18-4143-00: Hot Springs, AR 2025 SSES

Smoke Observation Summary

Address: 242 Hobson Ave

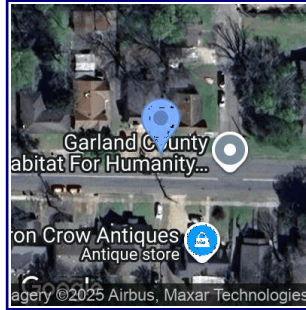
QC Comments: confirm where cleanout defect is - possibly above grade and 0 drainage area - CP
